## CITY of NOVI CITY COUNCIL

Agenda Item J  
January 26, 2015

**SUBJECT:** Approval of the request of West Oaks 1 Renovation JSP14-57, for Preliminary Site Plan and Stormwater Management Plan approval. The subject property is 20.12 acres in Section 15 of the City of Novi and located at 43741 West Oaks Drive in the RC, Regional Center district. The applicant is proposing a 17,291 square feet addition on the north and west sides of the existing center with associated parking and landscaping.

# West Oaks I Renovation JSP14-57

SCALE: 1" = 20'  
DRAWING NUMBER:  
**C-4.1**

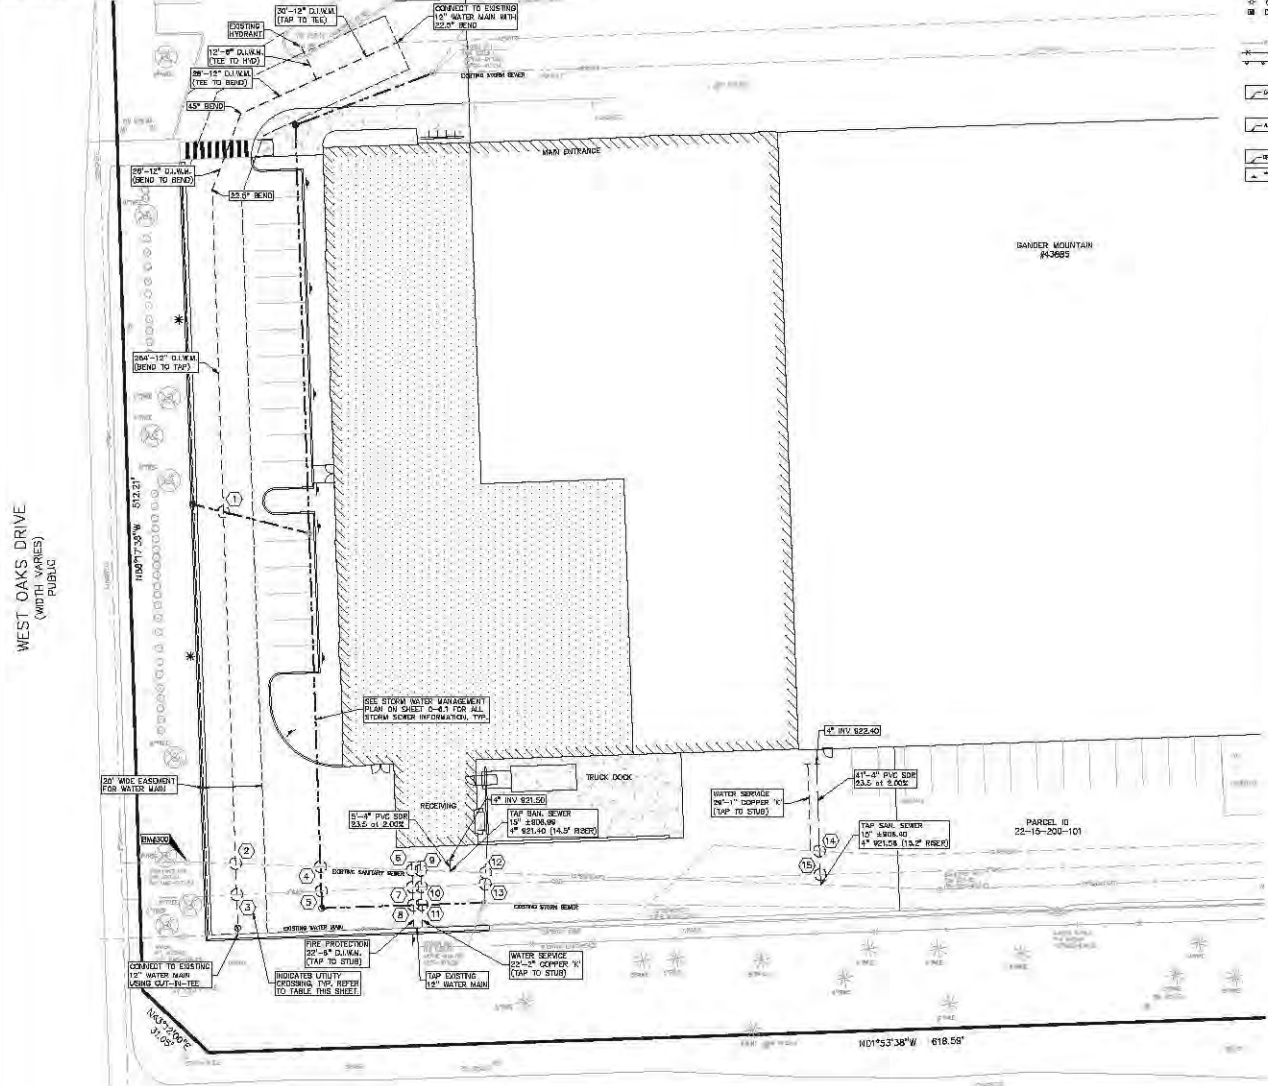
1. The height of the new east-west curb nearest the building is correctly indicated on the Grading Plan - North (sheet C-4.1) as 0.33 ft high (necessary to permit the abutting 17-ft-long parking stalls), but the two associated labels on the Dimension Plan – North (sheet C-3.1) are inconsistent with this requirement. The label to the east reads ‘6” Straight Face Curb Typ. Refer to detail on sheet C-8.1,’ and the label to the west reads “Straight Face Curb Typ. Refer to detail on sheet C-8.1.’ **Both of these two labels should read ‘4” Concrete Straight Face Curb, Typ. Refer to Detail on Sheet C-8.1.’** (Note: This is the label used on the first version of the revised preliminary site plan, which we were asked not to review since the proposed building footprint and related parking lot features were being changed to those now under review.)

1. The labels will be revised to read '4" Concrete Straight Face Curb, Typ. Refer to Detail on Sheet C-8.1'
2. Note 1 will be revised to specifically state that "parking space dimensions – length as well as width – are referenced to the face of curb or walk"
3. A note will be added to the plan specifying all signs shall be placed a minimum of 2 feet behind the back of curb.
4. No parking fire lane signs will be added in the landscaping area on the north side of the drive aisle. Note 4 will be revised accordingly.
5. The sign legend will be retitled to sign quantities and it will include the quantities of each sign type required.
